JOB TITLE CENTRAL FIRE STATION		SHEET TITLE DUCT CLARIFICATION	
HARRIS SHARP & ASSOC., INC. ARCHITECTURE-PLANNING-INTERIORS 2915 W. CHARLESTON BLVD. LAS VEGAS, NEVADA 89102 (702) 877-0125	JOB NO. 482-1	DATE 7/4/83	SHEET NO. Q-23
	DRAWN SAC	CHECKED DAD

JOB TITLE CENTRAL FIRE STATION		SHEET TITLE PROPOSAL #62	
HARRIS SHARP & ASSOC., INC. ARCHITECTURE-PLANNING-INTERIORS 2915 W. CHARLESTON BLVD. LAS VEGAS, NEVADA 89102 (702) 877-0125	JOB NO. 482-1	DATE 7-20-83	SHEET NO. Q-25
	DRAWN SAC	CHECKED DAD

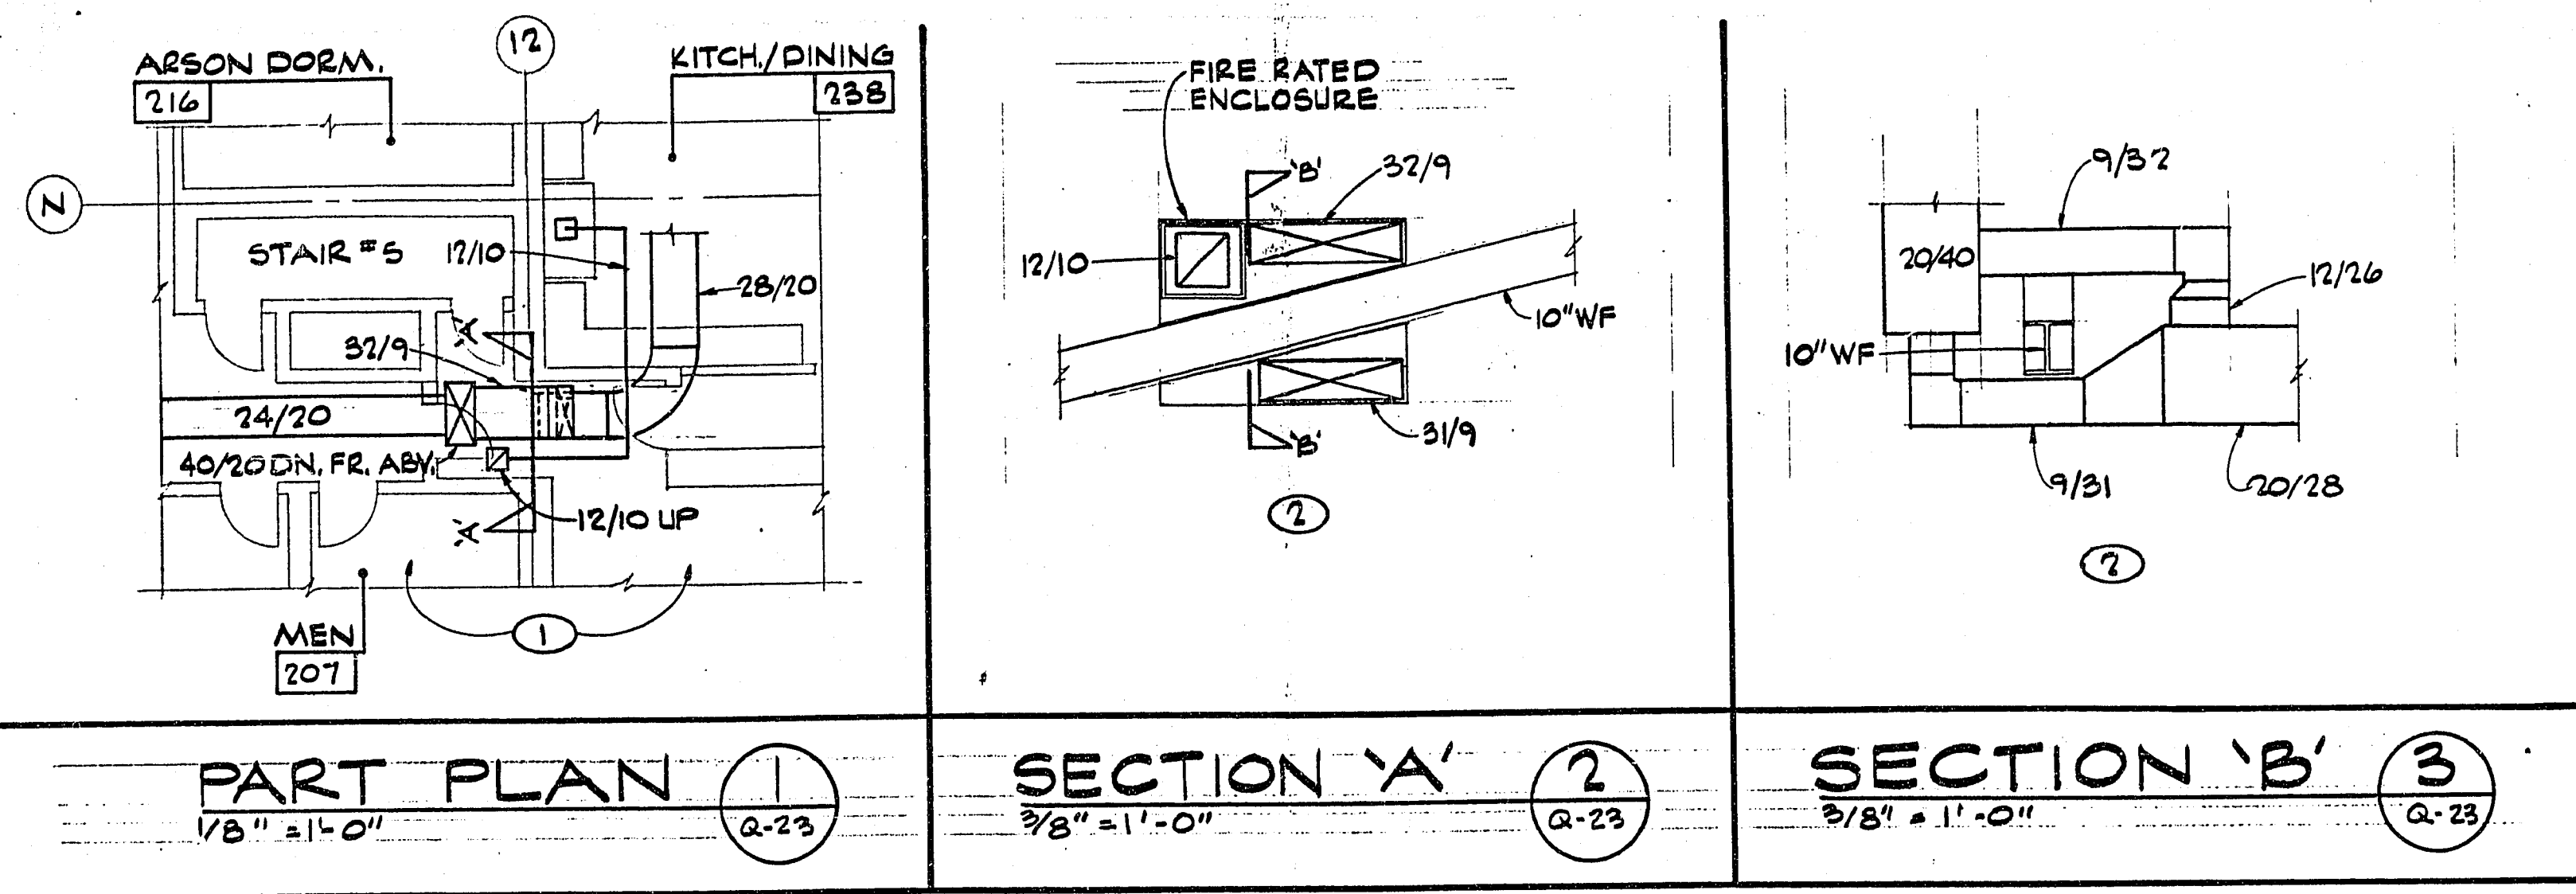
- ① FOR CONDITIONS NOT SHOWN ON THIS PART PLAN, REFER TO A-204
- ② THIS PLAN SHOWN FOR CLARIFICATION OF DUCT ROUTING. VERIFY ALL CONDITIONS IN FIELD PRIOR TO FABRICATION OF DUCTWORK.
